**Final Environmental Impact Statement**

**Conversion to Coal  
New England Power Company  
Salem Harbor Generating Station  
Units 1,2 and 3  
Salem, Essex County, Massachusetts**

October, 1982

Designation: Final Environmental Impact Statement

**FIGURE 2.0-2  
EXISTING SITE LAYOUT**

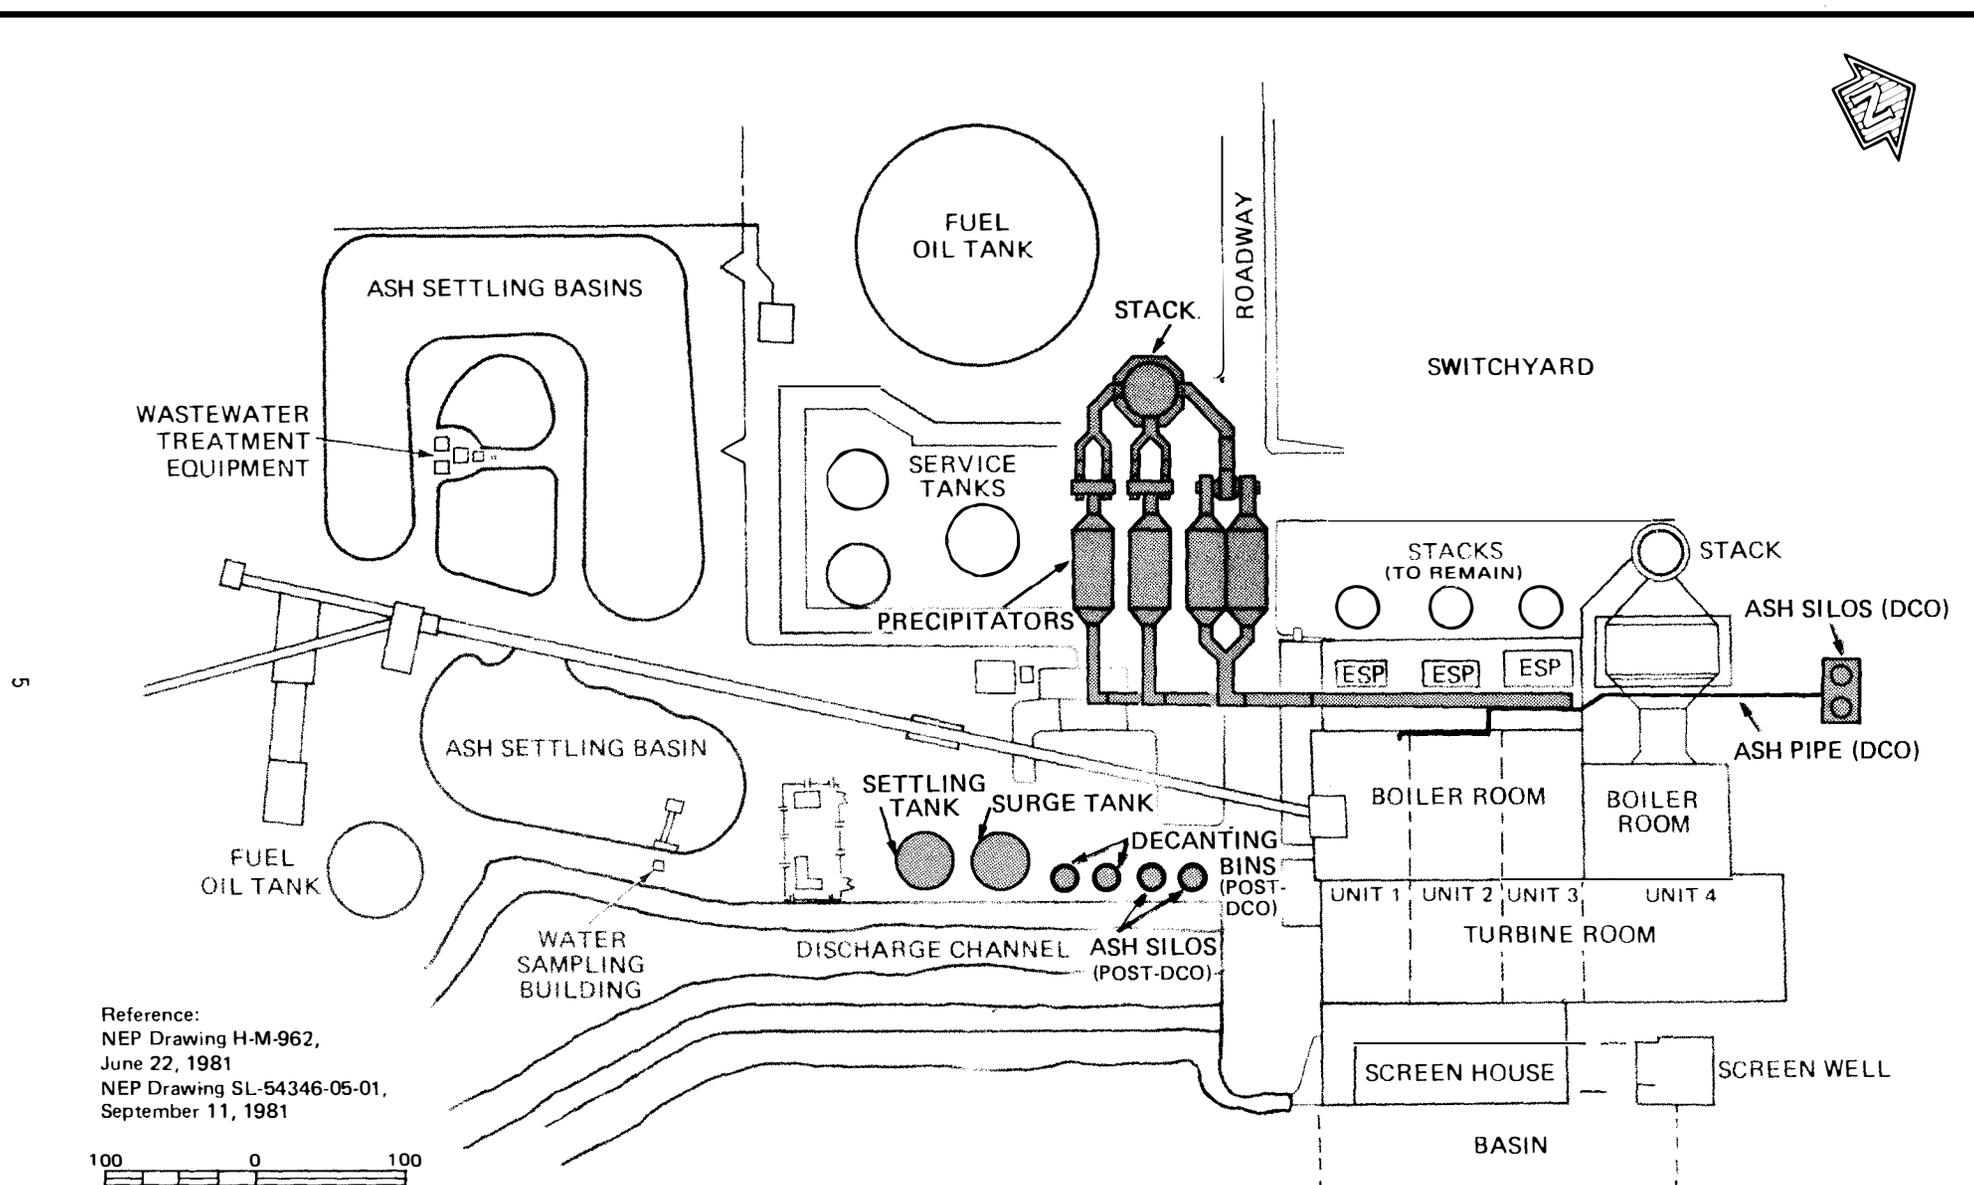
NEP plans to store approximately 190,000 tons of coal at the plant as an operating reserve (see Comment NEP-26 in Section 3.0). The existing pile, shown on Figure 2.0-2, will be enlarged slightly from its present 2.5 acres to accommodate the additional coal. The entire pile area will be enclosed within berms which will act both to collect pile runoff and protect from flooding during severe storms. Coal pile runoff will be collected in a lined ditch and directed to a lined holding basin. The basin will serve to prevent shock-loading of the treatment system. The runoff will then be pumped (at about 100 gpm) to the water treatment system described in Section 2.2.1.

The dock and tank farm portions of the generating station are within the 100-year floodplain as delineated on the HUD floodplain map for the City of Salem (see Figure 2.0-2 of this FEIS and Section 3.2 and Figure 3.2.1 in the DEIS). Some construction activities proposed in conjunction with conversion to coal will occur in these areas. In compliance with Executive Order 11988, "Floodplain Management," Water Resources Council's "Floodplain Management Guidelines," and Department of Energy regulations "Compliance with Floodplain/Wetlands Environmental Review Requirements" (10 CFR 1022), alternatives have been identified and their environmental impacts evaluated. The evaluation included public comments made during the review period for the DEIS. A preliminary conclusion has been made by the Department of Energy that no practicable alternative exists to locating the project in floodplains and that the proposed action is designed to minimize potential harm to or within the floodplain. Before action is taken on this project, the Secretary of Energy will reach a final conclusion on these matters. A Final Statement of Findings containing this conclusion will be published in the Federal Register with the Record of Decision on the project.

**FIGURE 2.0-3**  
**PROPOSED PLANT MODIFICATIONS (DESIGNATED BY SHADED AREAS)**

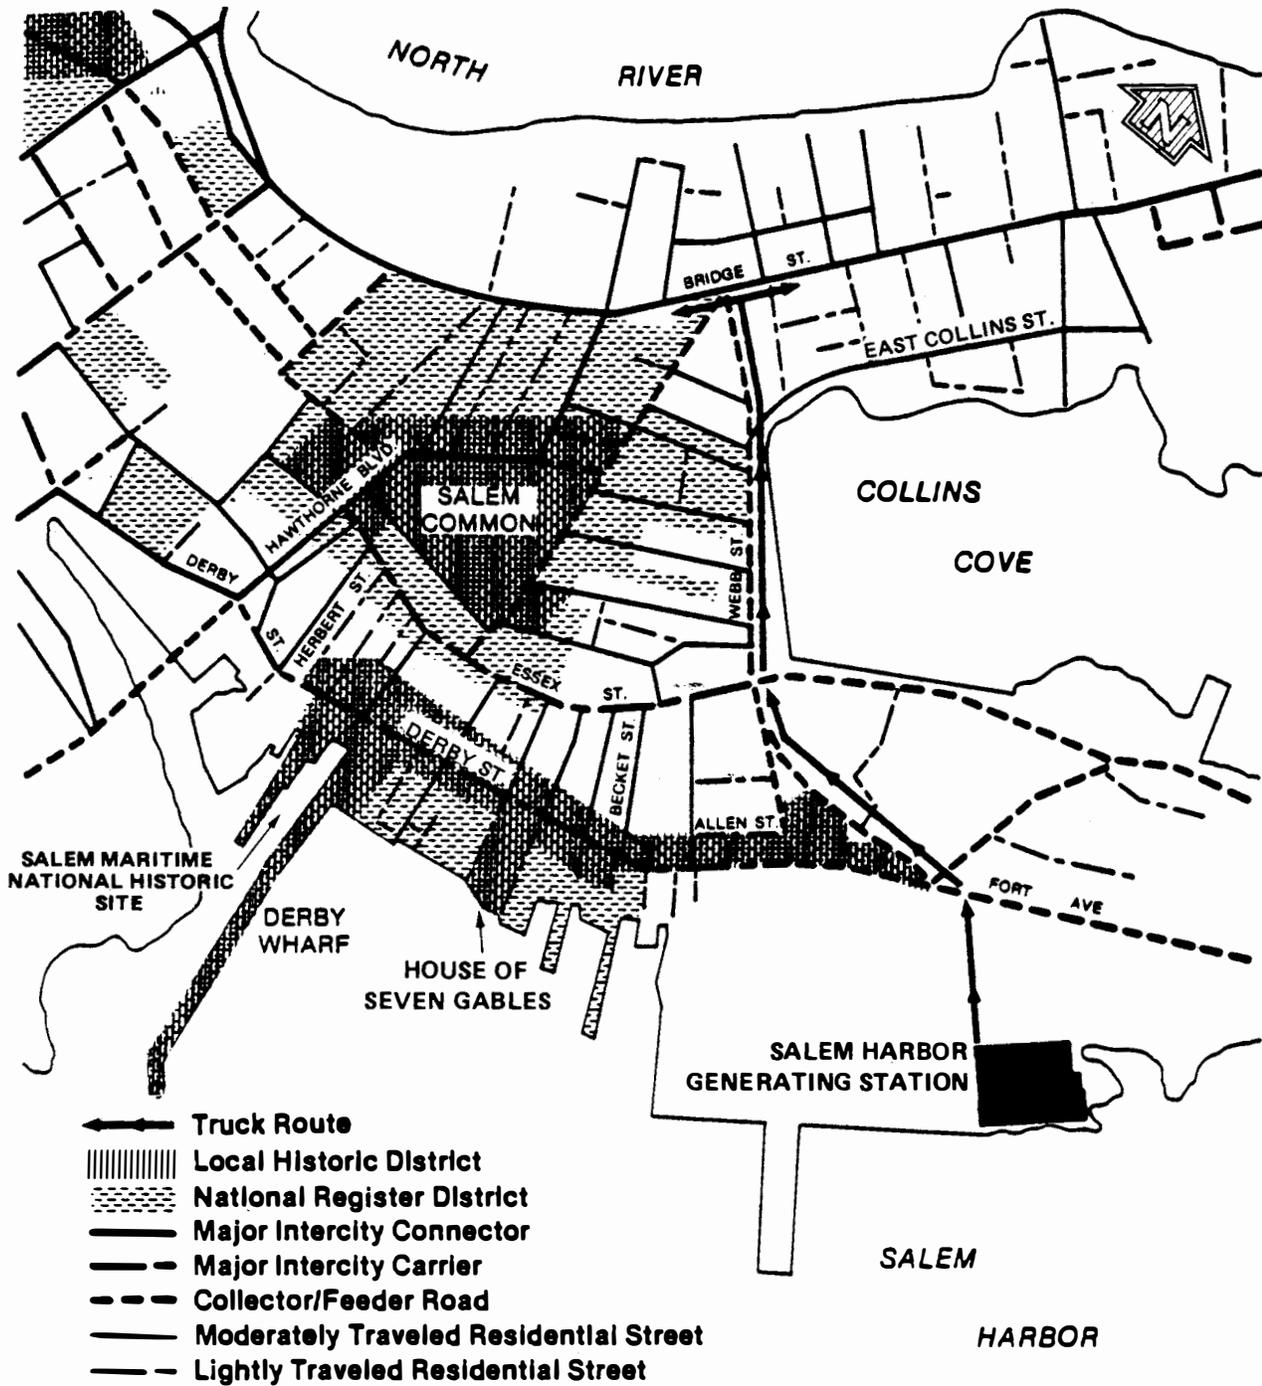
The wastewater treatment system at the Salem Harbor station (for location, see Figure 2.0-3) is designed to remove dissolved and suspended pollutants which are present in plant wastewater as a result of contact with coal and oil ash, boiler cleaning wastes, and general plant drains, including site runoff. The treatment process is based on lime precipitation. Wastes are first pumped into an equalization basin for flow control and pH damping. From there, they
